**STAFF REPORT**  
**WEST ALLIS PLAN COMMISSION**  
 Wednesday, May 29, 2019  
 6:00 PM

- 2A. Special Use Permit for Holiday Inn Express, a proposed hotel, to be located at 10201 W Lincoln Ave.
- 2B. Site, Landscaping and Architectural Plans for Holiday Inn Express, a proposed hotel, to be located at 10201 W Lincoln Ave, submitted by John T. Ford on behalf of the Lincoln Hospitality Group, LLC. (Tax Key No. 485-9996-007)

**Staff Recommended: Additional windows on east & west elevations**

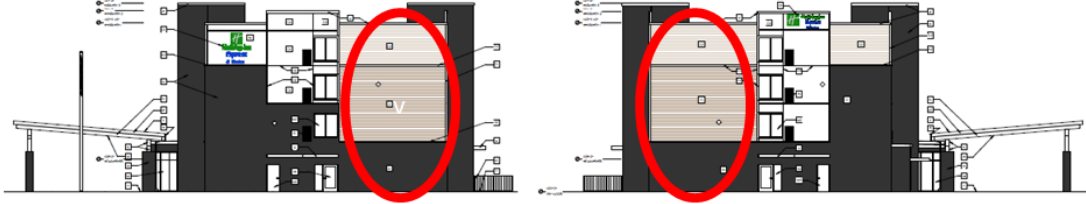
Windows and doors at entrances will be constructed of aluminum storefront systems (light bronze). Guest room windows will be constructed of aluminum (light bronze) and will be equipped with PTAC (packaged terminal air conditioners) located below the windows (champagne). Staff recommends that the storefront windows located at the building's entrance be replicated and continued throughout the first floor, in order to provide a more pedestrian-friendly approach and to add a greater sense of interest, openness and transparency to the design of the ground floor. Additionally, staff

recommends additional windows be included on the east and west building elevations, in order to avoid large areas of opaque façade and to remain consistent with the requirements made of similar development projects.

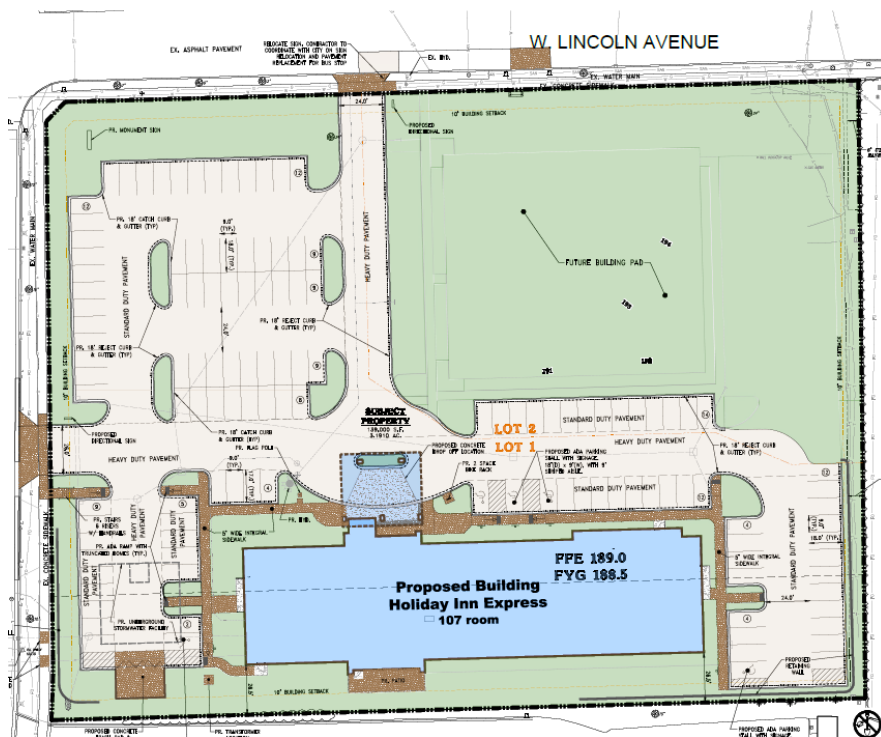
Vehicle access for the hotel will be available from the site's existing 102<sup>nd</sup> St. drive, as well as from a newly constructed Lincoln Ave. drive, which will be for vehicles turning right-in or turning right-out only. Pedestrian access to/from 102<sup>nd</sup> St. is included in the initial phase of development, with additional pedestrian access to Lincoln Ave. included as part of the future development project. Staff recommends that a pedestrian crossing area between the hotel entrance and the sidewalk connecting to Lincoln Ave. be shown on the site plan.

- identified as Phase 1, Phase 2, and Contingency Plan; (b) City Forester approval of the landscaping species and number; (c) additional pedestrian connection/crossing from hotel entrance toward Lincoln Avenue; (d) sidewalk/pedestrian connection to Lincoln Ave. clearly identified on the Contingency Plan; (e) Implement by date included on Contingency Plan; (f) revised window plan for the first floor, as approved by staff; (g) additional windows added to the east and west elevation, as approved by staff; (h) staff approval of material and color samples; and (i) City Engineer approval of new entrance/drive location and design. Contact Katie Bennett, City Planner at 414-302-8463.

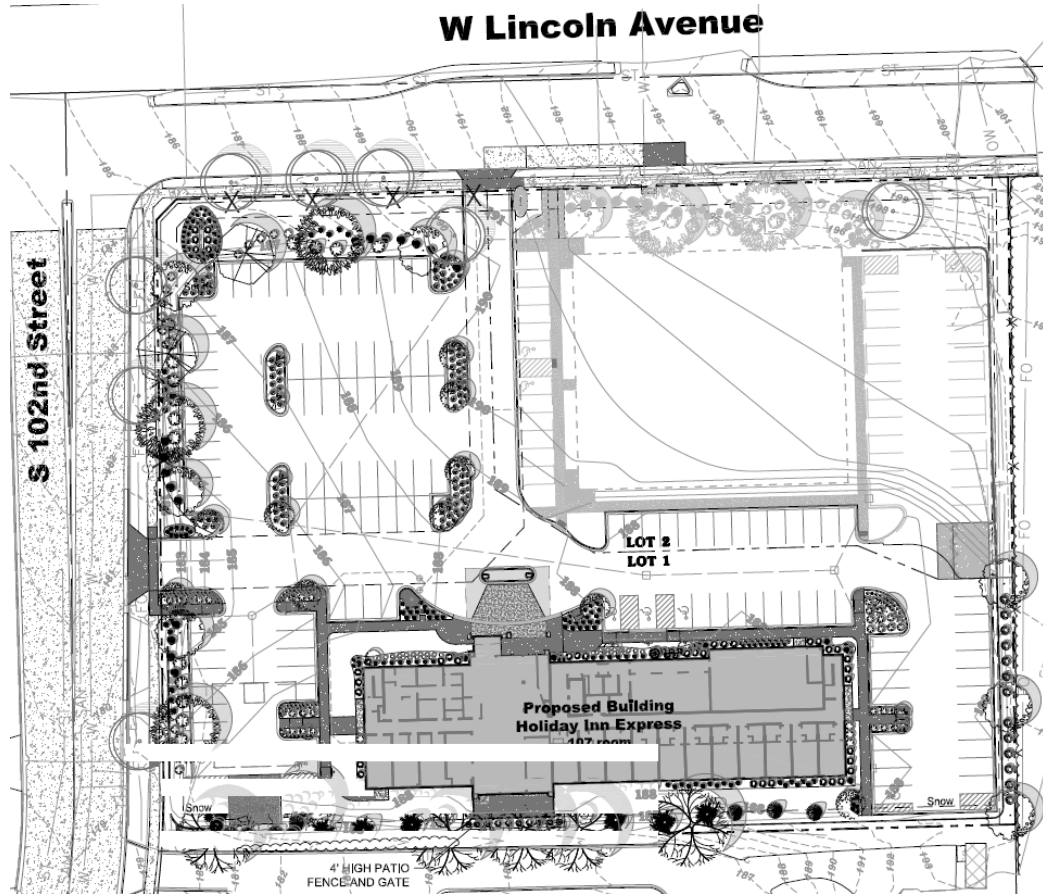
For the initial development project, a wide selection of deciduous trees and shrubs, evergreen trees and shrubs, and perennials are proposed on Lot 1. As part of the contingency plan, should no development be underway on Lot 2 by June 2021, additional landscaping is proposed along Lincoln Ave. Staff recommends that a sidewalk/pedestrian connection from the hotel to Lincoln Ave. also be clearly identified as part of the contingency plan.
